July 28, 1982 Design Audit

Topic - Construction Dewatering for Underpinning

Midland Power Plant
Units 1 & 2

APPLICANT: Consumers Power Company
FACILITY: Midland Plant, Units 1 & 2
SUBJECT: SUMMARY OF FEBRUARY 27 & 28, 1980 MEETING AND SITE TOUR WITH CONSULTANTS TO REVIEW SOIL SETTLEMENT

GRAIN SIZE DISTRIBUTION

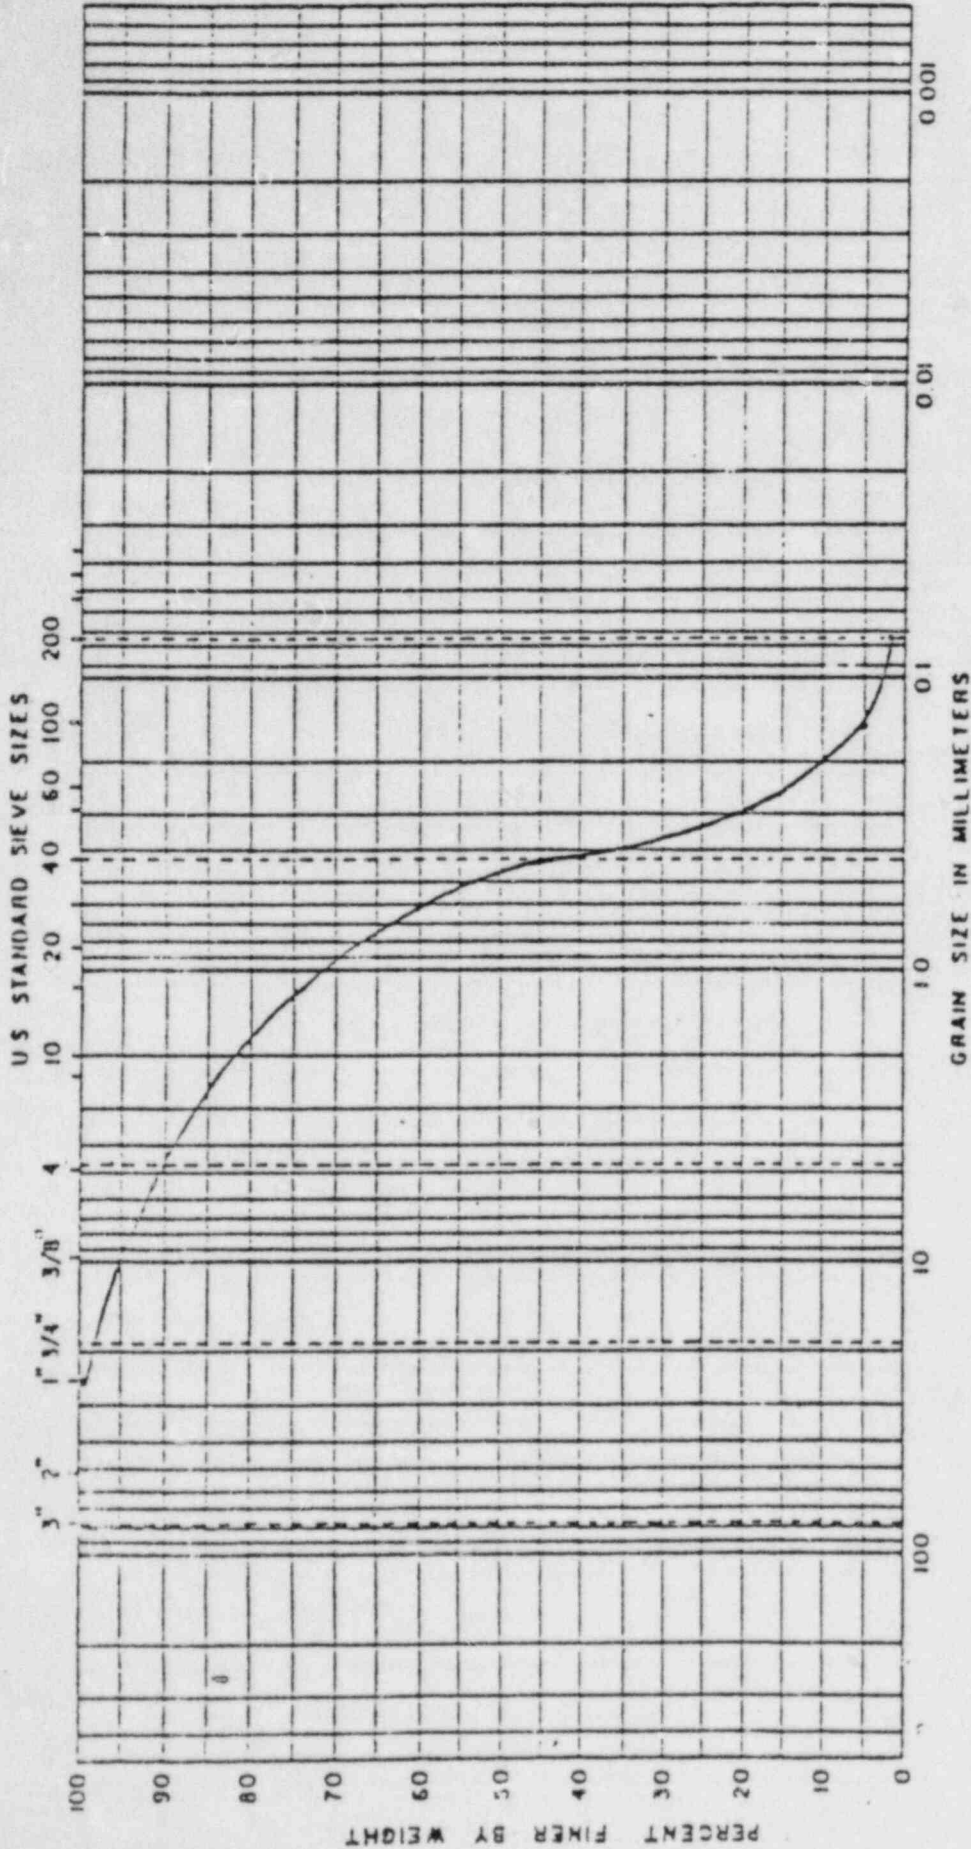
Furnished by GEI
CPC has committed to adopting the testing
procedures in controlling the granular⁴³-fill
beneath the FIVP

MELTING POWER PLANT
 DATE: AUG 1968
FIGURE 10
Tom Cooke

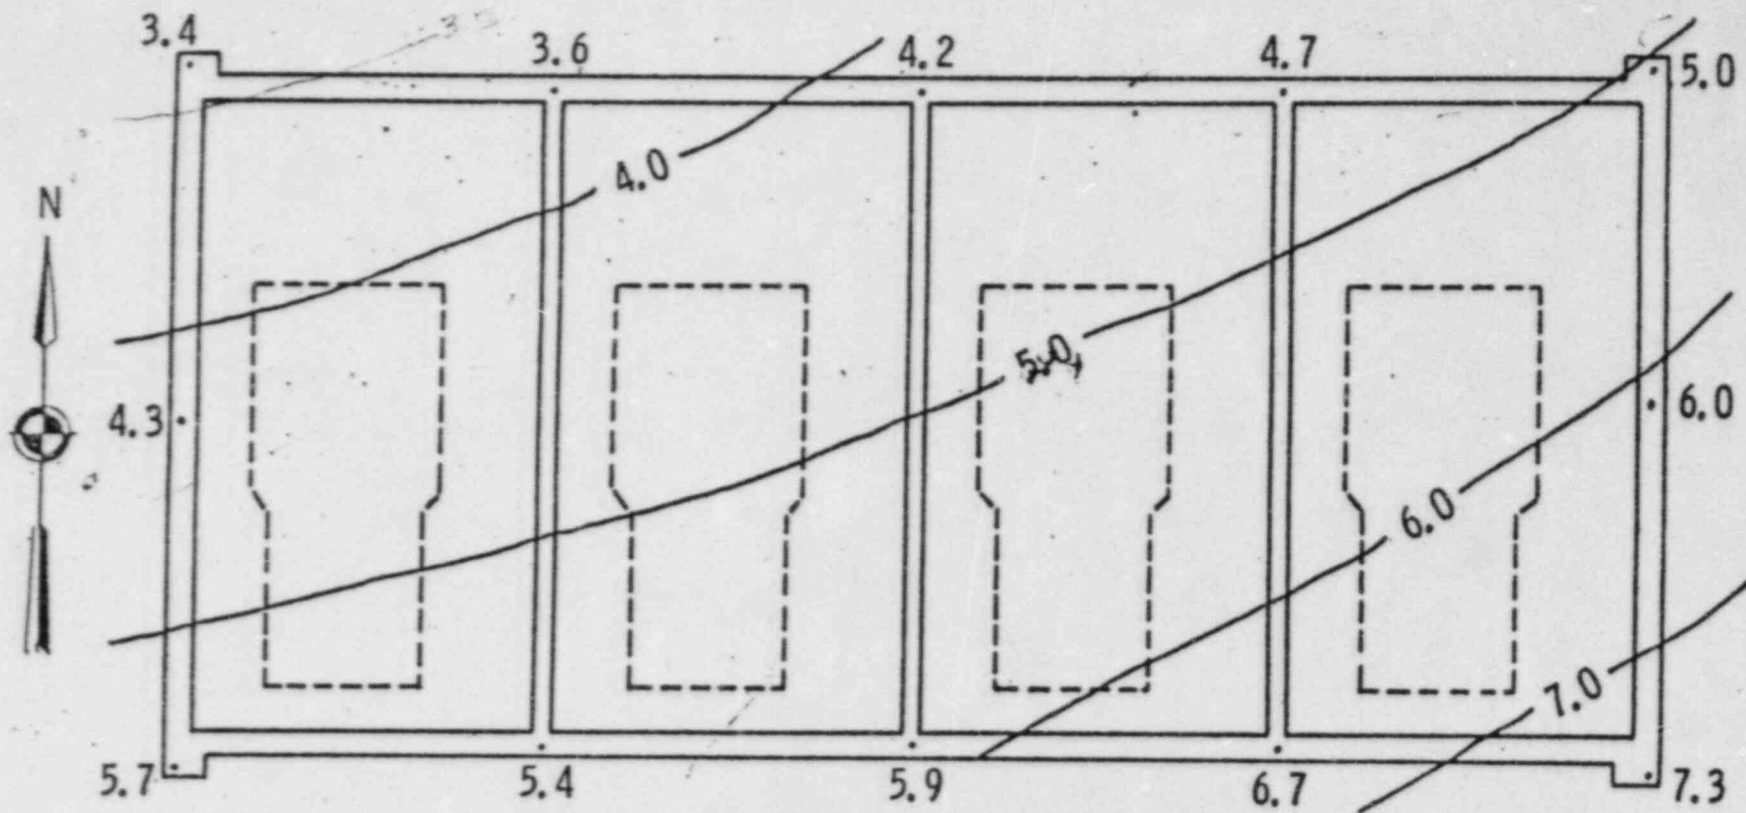
*Compare this to
Figs. 27-10 & 27-11
in Vol. 2*
